**MAINE DEPARTMENT OF
INLAND FISHERIES AND WILDLIFE**

ADDENDUM NO. 2

**EFFLUENT CHARACTERISTIC DESIGN AT
EMBDEN REARING STATION**

BGS PROJECT NO.: 3289

SLUDGE MIXING PUMP BUILDING
STRUCTURAL PLANS

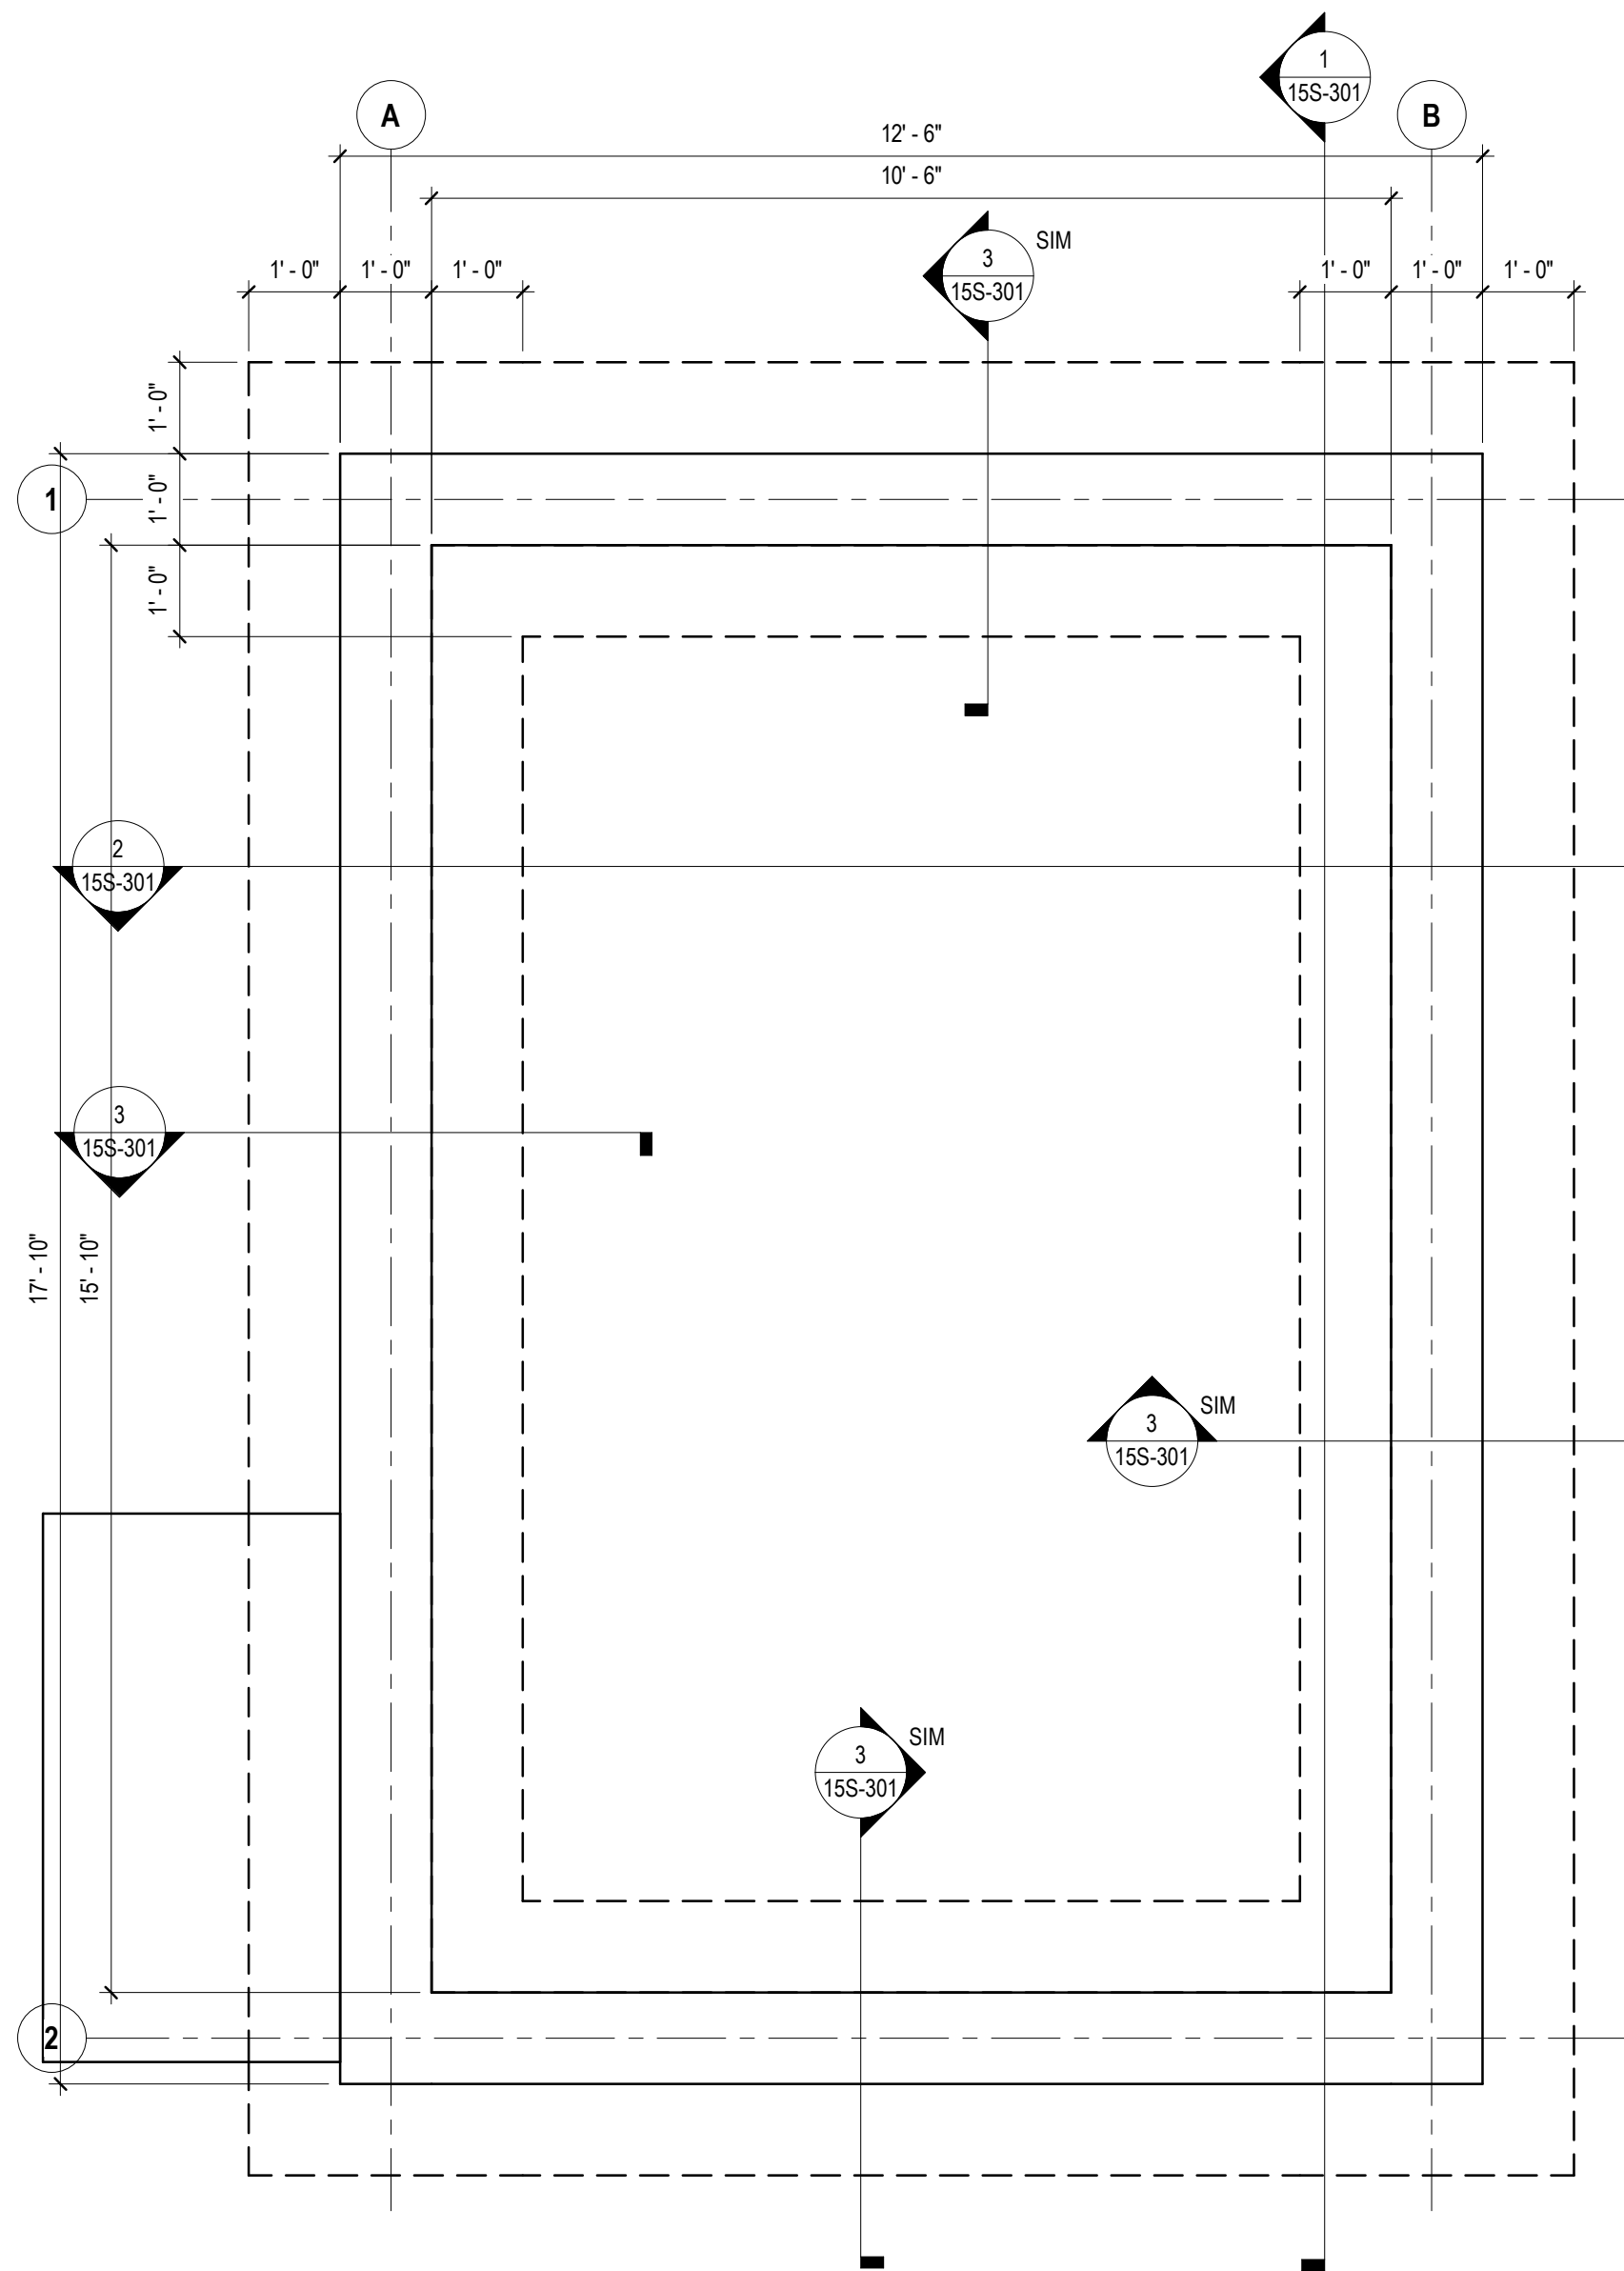
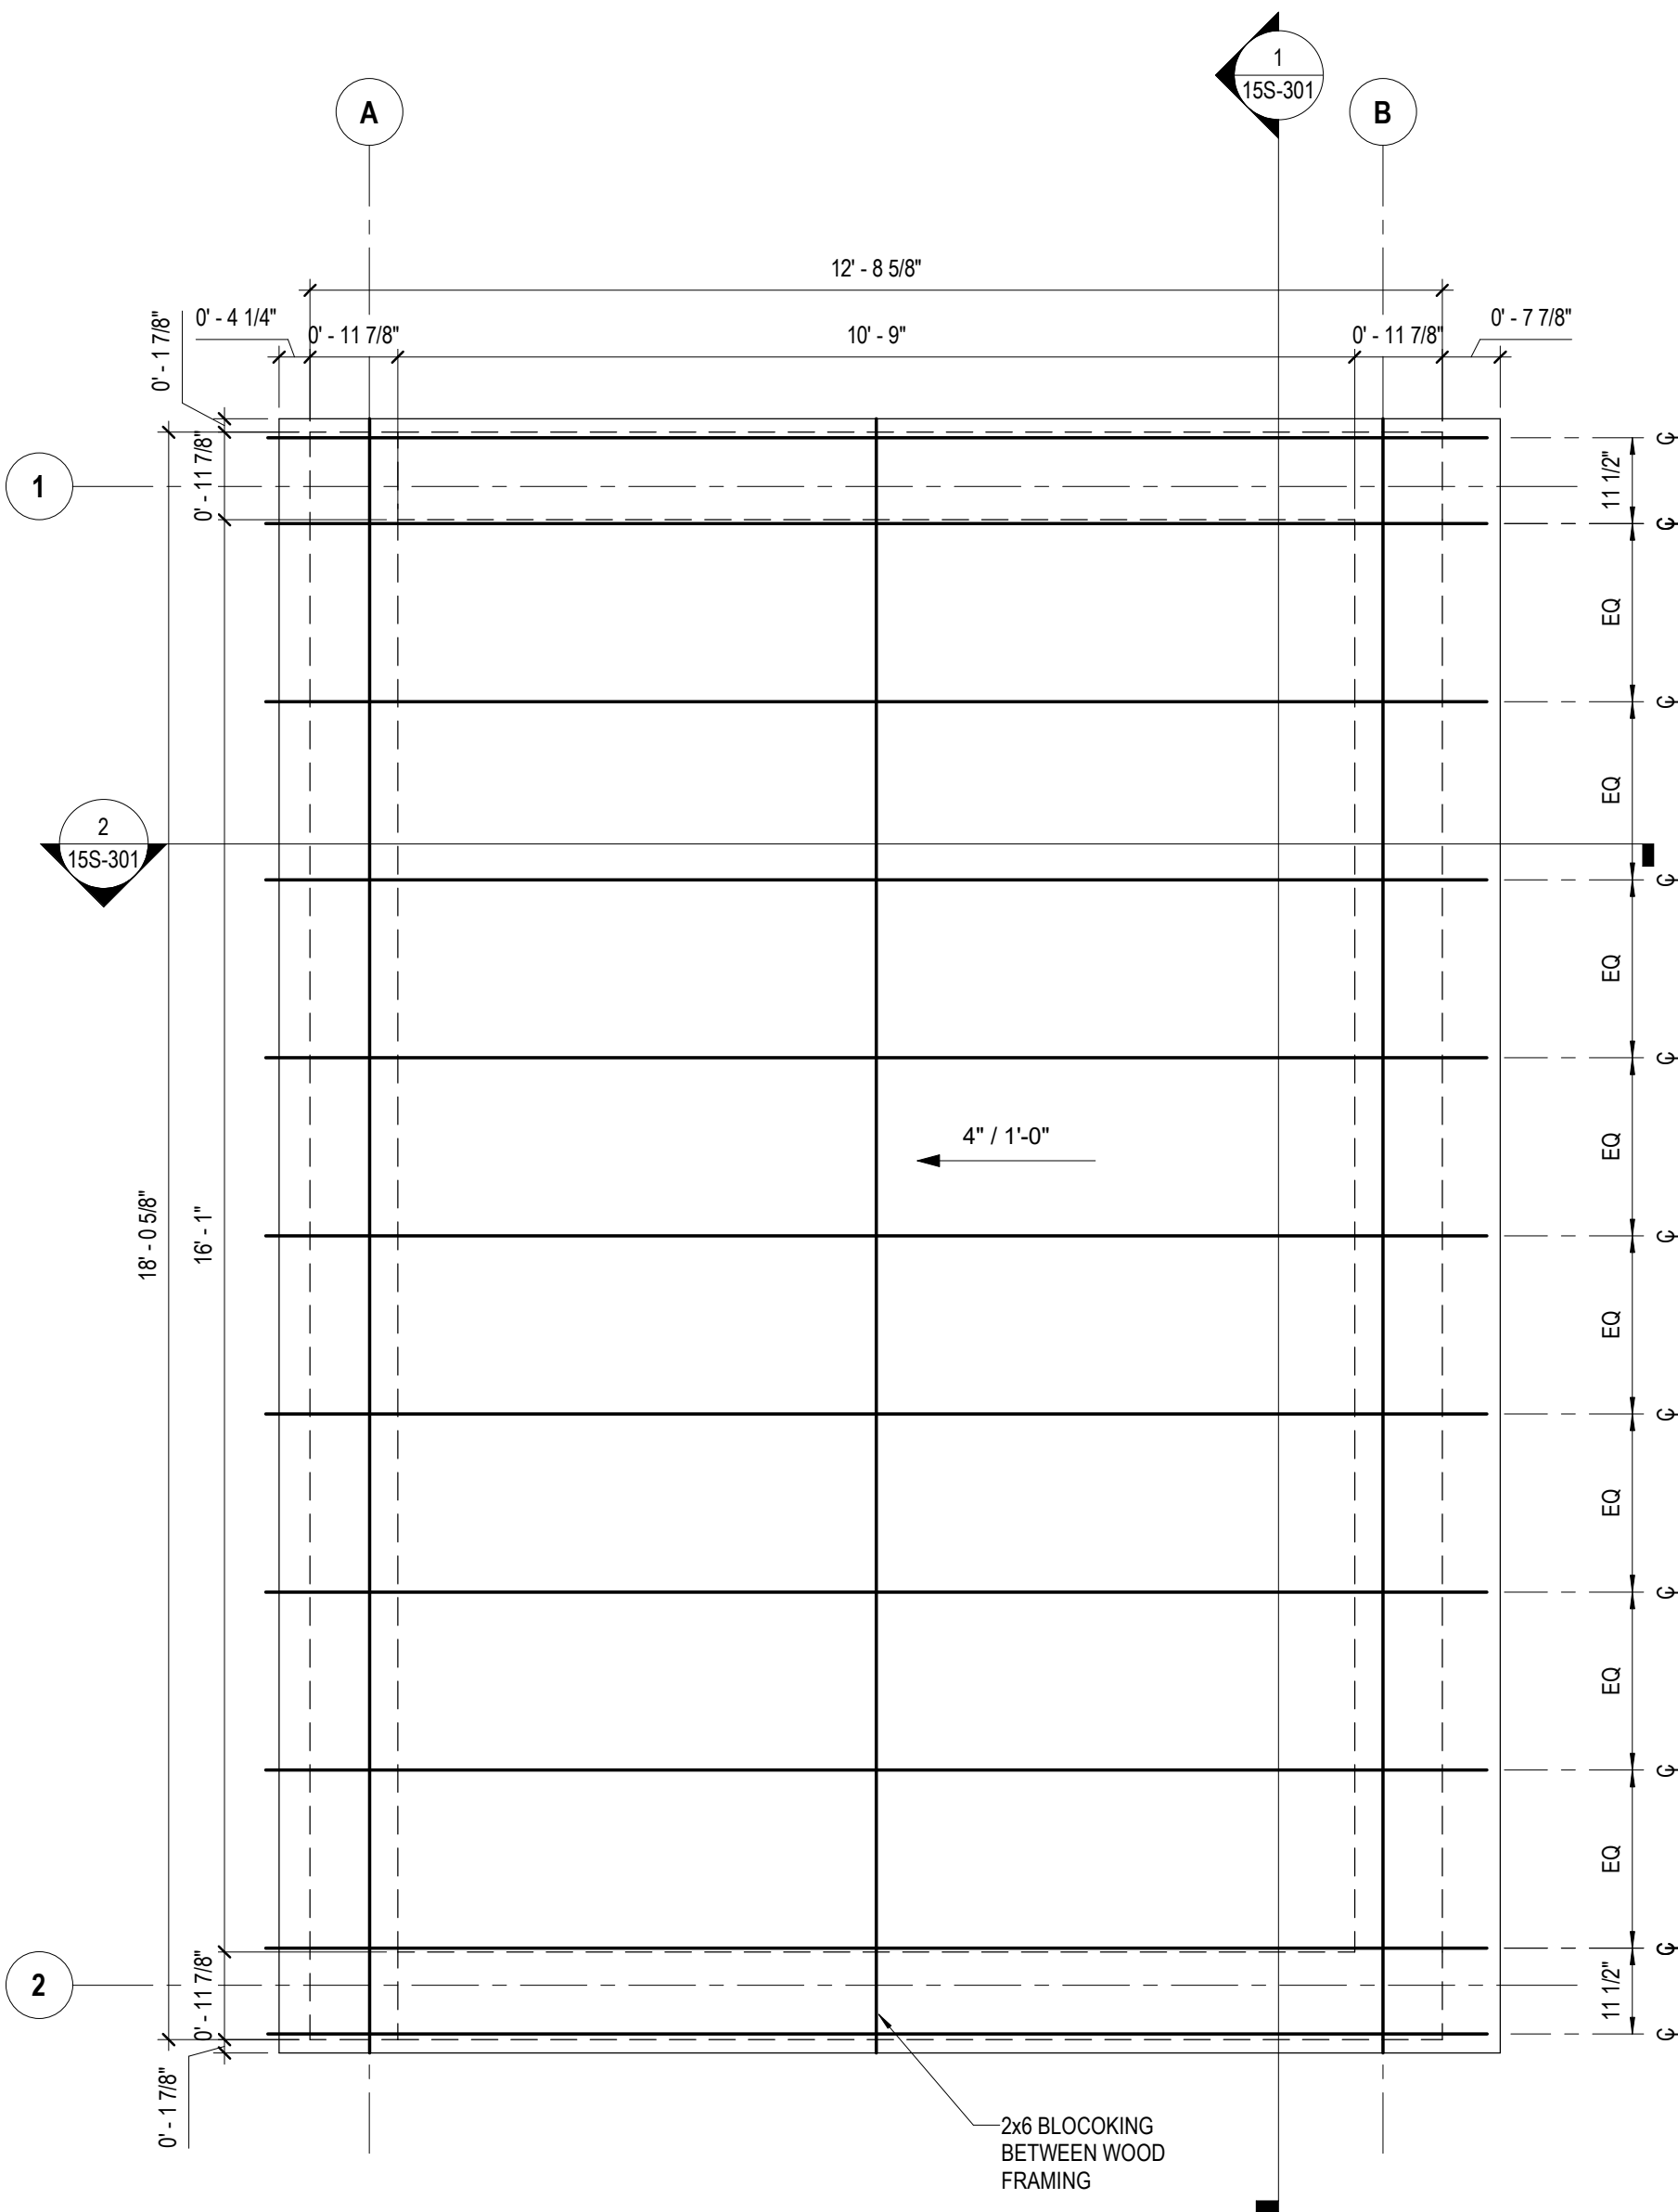
- 59. QUESTION:** 15S-101 : SLUDGE STORAGE TANK STRUCTURAL PLANS: 15S-101 : This sheet it titled: Sludge Storage Tank Structural Plans. The plans on this sheet are for Sludge Pump Building Structural Plans.

- 62. QUESTION:** 15S-101 : SLUDGE STORAGE TANK STRUCTURAL PLANS: Sludge Building Foundation Plan: At column #2/A - Please confirm rectangle represents propane tank pad (Sheet 15M-101). Sheet 1/5D-401 does not show this information. Please confirm the scope of work, details and specifications on all the Civil and corresponding sheets

- 63. QUESTION:** 15S-101 : SLUDGE STORAGE TANK STRUCTURAL PLANS: What is the roof framing to be installed?

ANSWER: The title of the sheet should be SLUDGE MIXING PUMP BUILDING.
SOURCE: Eva Schaible eschaible@phelanconstruction.com Thu 10/17/2024 11:49
- 60. QUESTION:** 15S-101 : SLUDGE STORAGE TANK STRUCTURAL PLANS: General Note # 1: Please confirm sheet 00S-100 for general structural notes. There are sheets 10S-001

ANSWER: The exterior pad measures 6'-0" x 3'-0" and shall have an 8" thick slab reinforced w/ #4@12" on center, each way, 2" clear from the top of the slab. The slab shall be constructed flat and have a perimeter wall and backfill similar to detail 5/10S-502. There are two pipe bollards, one at each corner of the slab.

ANSWER: Roof rafters shall be 2x12 @ 16" O.C.

SHEET
15S-302

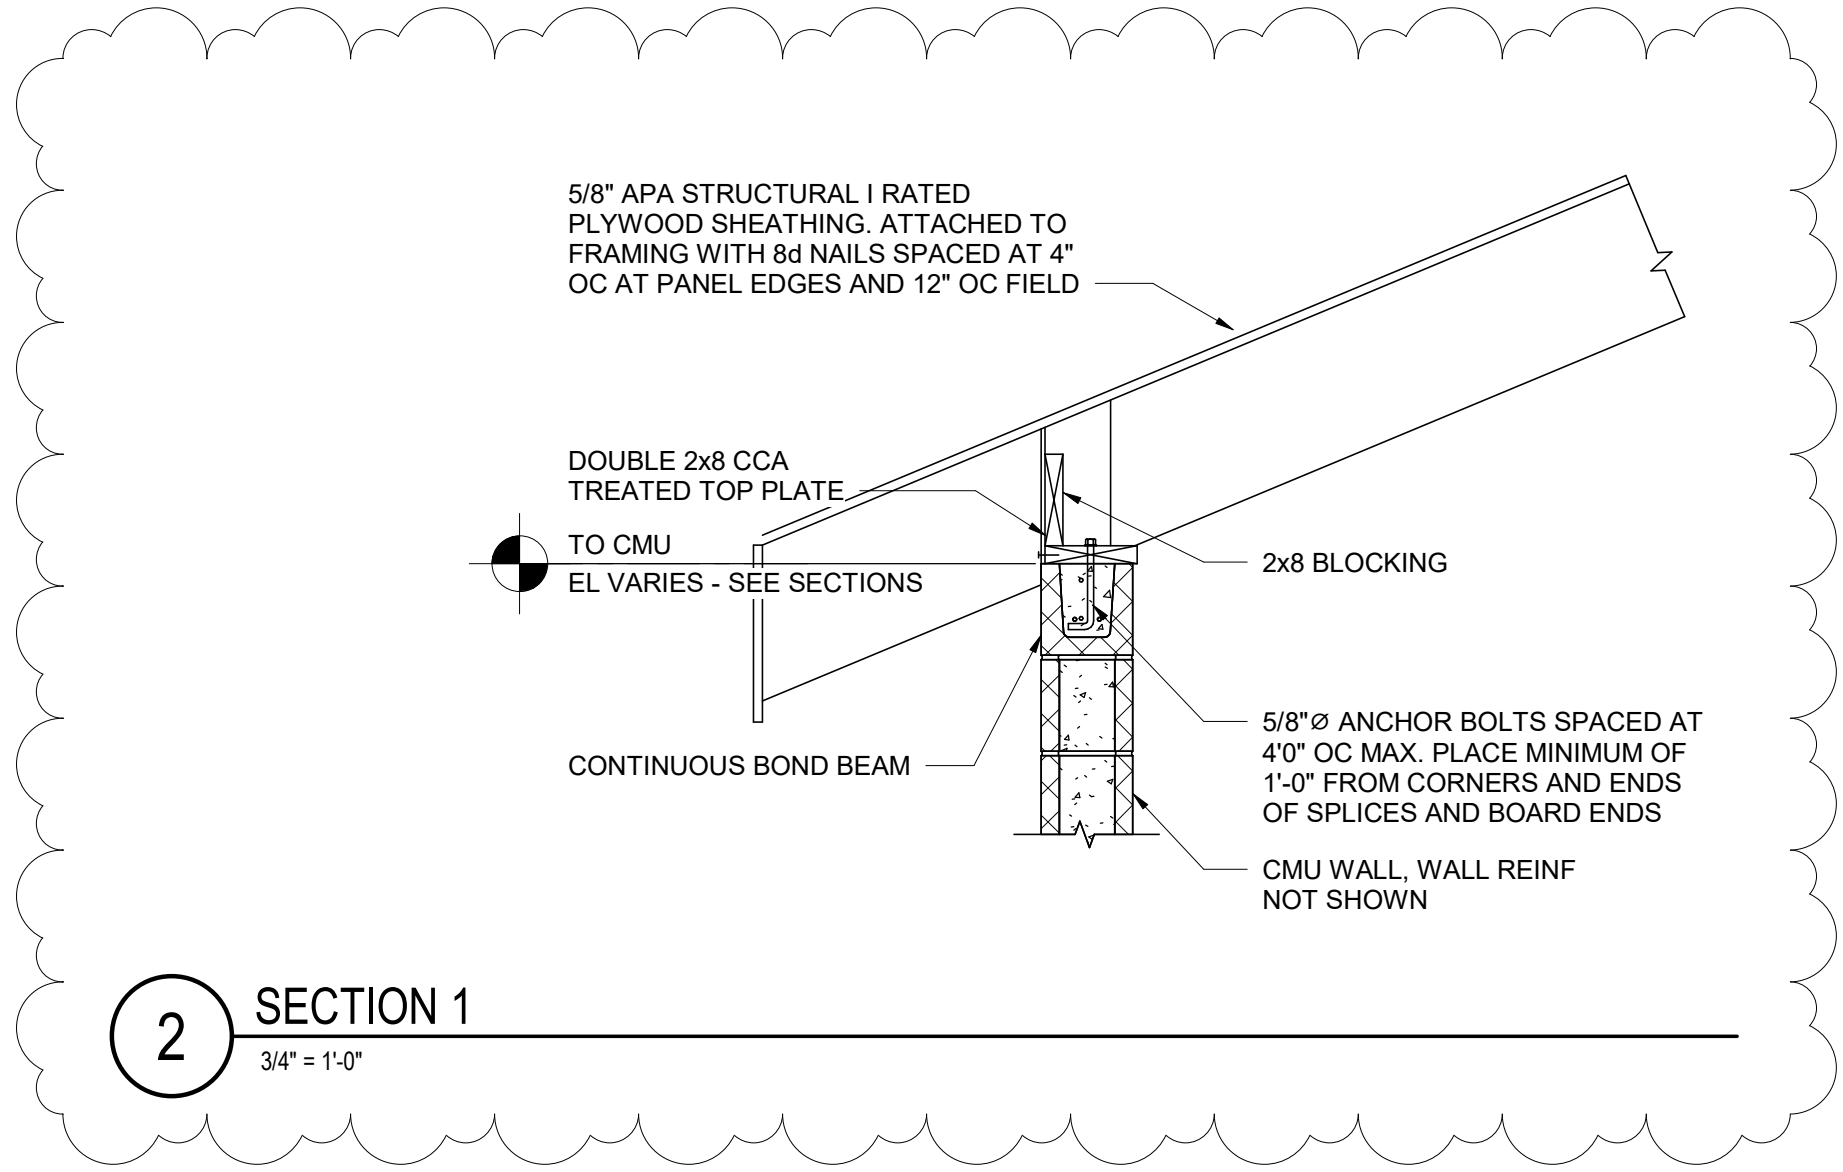
- 66. QUESTION:** 15S-302 : SLUDGE MIXING PUMP BUILDING ROOF FRAMING SECTIONS AND DETAILS: Detail 4/15S -302: Please confirm the additional notes and dimension for this detail, there are no notes shown. Is the 8" cmu wall offset on the column line at the footing?

- 67. QUESTION:** 15S-302 : SLUDGE MIXING PUMP BUILDING ROOF FRAMING SECTIONS AND DETAILS: Detail 2/15S -302: Please confirm where this detail is referenced from. Top of CMU 247.00 vs the TO Wall 406'-2" or 406" 15S-301

- 68. QUESTION:** 15S-302 : SLUDGE MIXING PUMP BUILDING ROOF FRAMING SECTIONS AND DETAILS: For the 7 1/4" insulated concrete slab floor, please confirm this detail for insulation and concrete. This detail shows the insulation embedded in the concrete. What is the depth

ANSWER: Notes have been added to the detail. The CMU wall shall be centered on the foundation wall.

ANSWER: Elevation note revised to reference sections.

ANSWER: The floor shall consist of a 4" reinforced concrete slab, vapor retarder over the concrete, 2" rigid insulation, then 2" concrete topping slab with welded wire mesh reinforcing. Align the top of the topping slab with the top of the foundation walls.

- 119. SHEET 15S-302**
- a. **UPDATE:** Sheet - Elevation note revised to reference sections.
- 120. SHEET 15M-101-**
- a. **ADD:** “Note: Provide ½ inch SCH40 black steel pipe and fittings from propane tank pad to Gas fired unit heater SH-1. Include dirt leg, gas cock, sealed wall penetration, isolation valve above tank pad and ground joint union at heater. Paint piping per 09 96 00.”
